Subject: Alameda / San Pedro Development Traffic Impact Study

Southeast corner of Alameda and San Pedro Albuquerque, Bernalillo County, New Mexico

This letter is to inform you that the **FINAL** Traffic Impact Study (TIS) for the proposed Alameda / San Pedro Development at the southeast corner of Alameda and San Pedro dated January 23, 2019 has been reviewed.

EXHIBIT A

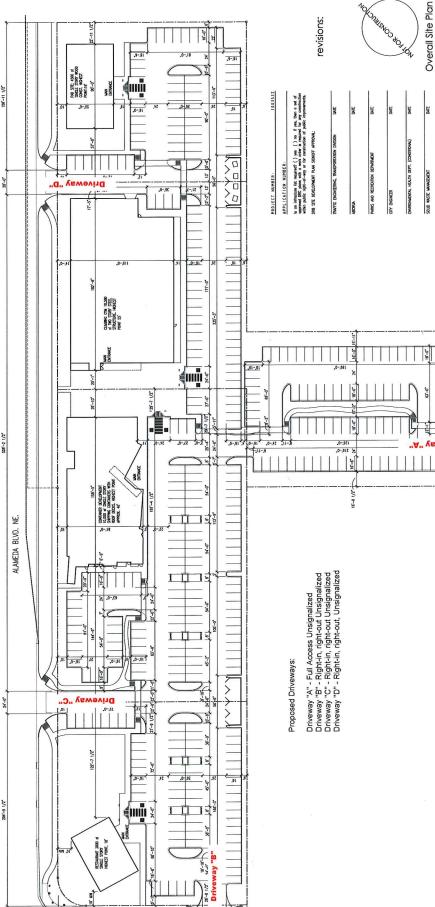
The NMDOT has no objection to the (2) partial Right In/Out only access points on Alameda eastbound located approximately 265 feet and 820 feet east of the signalized intersection of Alameda and San Pedro, east of I-25. See Exhibit A for the conceptual site plan.

1. The development shall provide pedestrian connectivity along the frontage of its property and update the ADA curb ramps as needed on Alameda.
